<b>Docket Number:</b>	17-BSTD-02
<b>Project Title:</b>	2019 Title 24, Part 6, Building Energy Efficiency Standards Rulemaking
<b>TN #:</b>	222765
<b>Document Title:</b>	Field Controls - Mark Lundberg Comments Central Fan Integrated Mechanical Ventilation Modeling
<b>Description:</b>	N/A
<b>Filer:</b>	System
<b>Organization:</b>	Field Controls - Mark Lundberg
<b>Submitter Role:</b>	Public
<b>Submission Date:</b>	2/28/2018 9:34:49 AM
<b>Docketed Date:</b>	2/28/2018

## **Central Fan Integrated Mechanical Ventilation Modeling**

**Subject: Comment on Central Fan Integrated Mechanical Ventilation Associated with 2019 Building Energy Efficiency Standards Rulemaking (45 Day Review) to California Code of Regulations, Title 24**

**TABLE 2: Energy Plus modeling results of Electric Usage with Exhaust ventilation (Point 1) and CFI supply ventilation (Point 2) in CZ10**

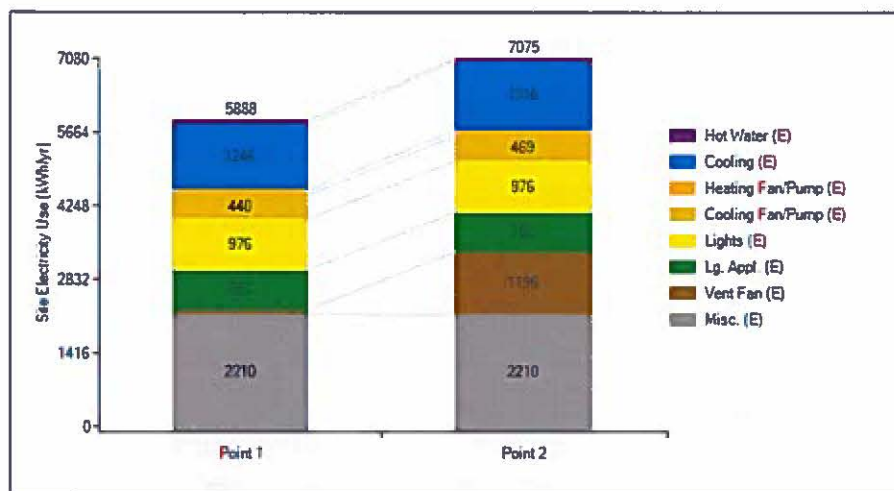
For comparison, another widely used energy modeling package, Energy Plus, puts the incremental energy of a CFI system in a similarly constructed house at 1,200 kWh and a savings of 26 therms, more than 80% lower than CBECC-RES, as shown in Tables 2 and 3.

**FIGURE 2: Air and Energy Flows in California Title 24 Software, Exhaust & CFI**

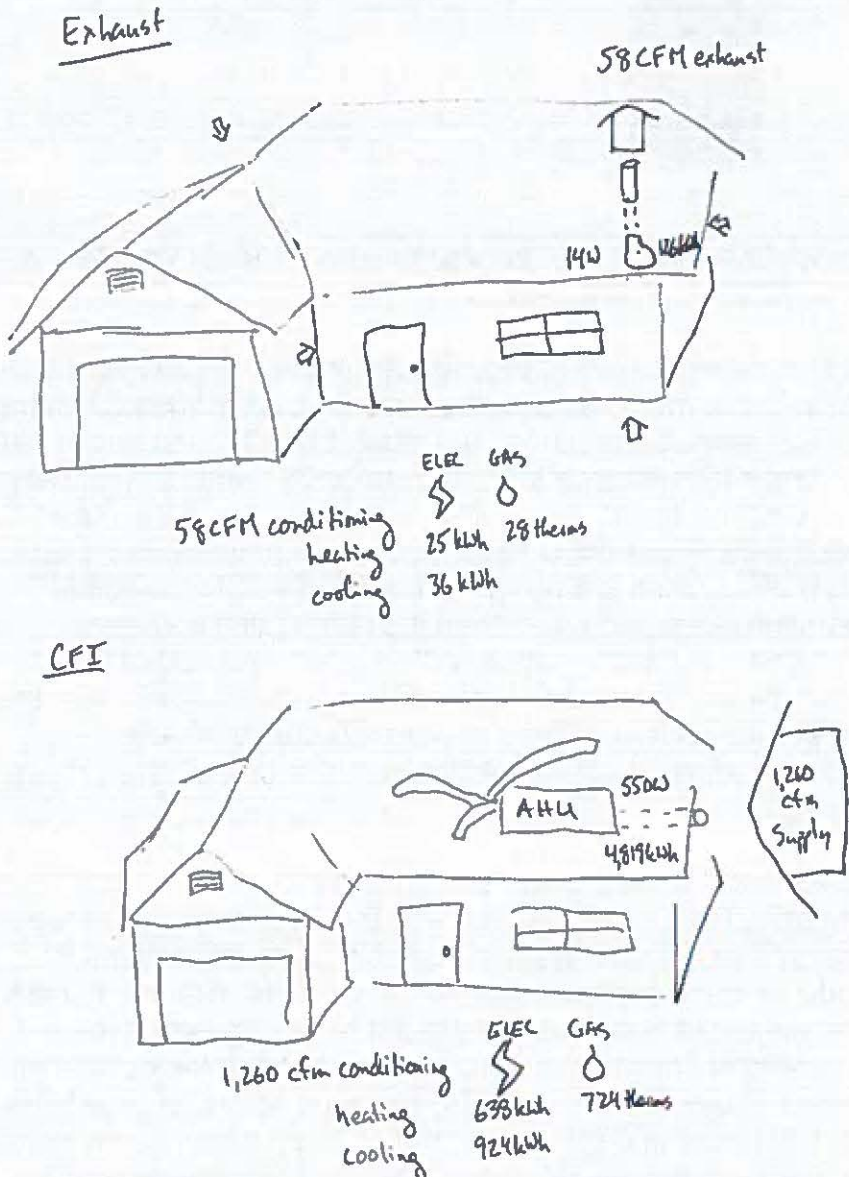
By digging through the temporary files, we discovered why the disparity exists between real world and modeled energy use. The software assumes that the CFI system is continuously bringing outside air into the house equal to the full CFM of the air handler fan. This far overstates the amount of outside air ventilation of CFI systems, which drives up the heating and cooling energy demand in the house to bring the outside air to temperature setpoint. Figure 1 shows the CBECC-RES modeled air and energy flows in an example exhaust and CFI house in CZ10. Since the software assumes the same amount of outside air is also brought into the reference building, compliance margin does not suffer significantly in a house with prescriptive standard heating and cooling equipment. Thus, the 2016 code does not place an undue burden on CFI systems for compliance. However, the net-zero code due to go into effect in 2020 will require PV

CFI systems typically operate the central fan only intermittently, 10 minutes on and 20 minutes off, for instance. This cuts fan and conditioning energy by 2/3, relative to current calculations. The second change needed is the proportion of total fan cfm bringing in outside air. Typical CFI systems are set up to bring 10-20% of total fan cfm in from outside when the damper is opened. Current software assumes 100% is outside air. A properly installed CFI system requires no additional energy to condition outside air than an exhaust system; both are set to meet Title-24 adopted ASHRAE 62.2 cfm rates, and the software should reflect that.

- 1) If heating or cooling energy occurs in a given 60 minute period, CFI system will time its operation to coincide, so there is no incremental mechanical ventilation fan energy in the house that hour
- 2) If no heating or cooling energy occurs in a given 60 minute period, CFI system will operate for 20 or 30 minutes with full operation of the air handling unit at max cfm, bringing in outside air at exactly ASHRAE 62.2 whole-building continuous ventilation cfm rate specified by Title 24.
